Please find below responses to questions as outlined in your respective e-mails regarding the Mine Permit Amendment Application for Mount Polley Mine.

M-290
Item 1

Item 1 – Tailings Storage Facility Calculation

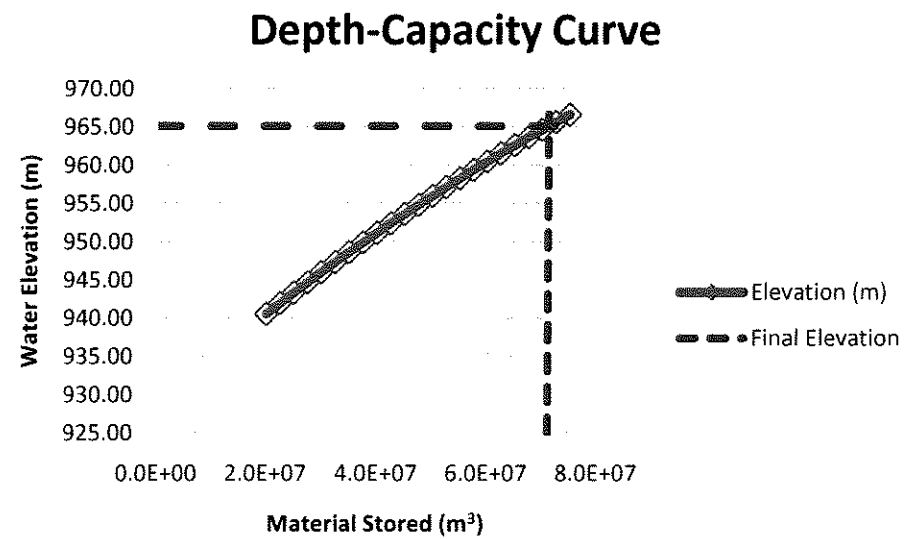
1. Review and supply supporting documentation that projected tailings amount will fit into the TSF (970m).

11. The application indicates that there is sufficient capacity in the permitted TSF to store the additional water from the proposed mine development however page 39 indicates additional dam construction will be required near end of mine life presumably to store additional tailings. There is no report from the design consultant to indicate required dam height or confirm that additional dam construction is feasible.

Based on internal documents including LOM tonnages (32,041,000t of Mill Feed at 2.60 S.G.) and the water balance, in combination with the Tailings Storage Facility (TSF) depth-capacity curve as designed by Knight Piésold, it is projected that all material produced as a result of continuing mining operations, as well as additional items contained within the permit amendment, will be able to be stored within the Dam structure as designed. Final projected elevation of the TSF is 966.51m (freeboard included), with current ultimate design to 970.0m. Full calculations are as included in **Item 1**.

Existing Dam data is as of the end of November and is calculated from the Water Balance (Mount Polley). Projected Values are as per Mount Polley Reserves (Mount Polley) and the Depth-Capacity Curve (Knight Piésold).

Cumulative tailings to date are as per daily mill throughputs, compiled from daily mill and mine operations data. Water contained in the dam is tracked by means of the water balance, which accounts for all surface and sub-surface water flows collected by various ditches and pipelines that report to the TSF. Water elevation is modeled by the depth-capacity curve provided by Knight Piésold as relating to the dam design, and is verified by monthly surveys of the water surface elevation. A storm and freeboard allowance of 1.39m is added to the projected TSF water level.
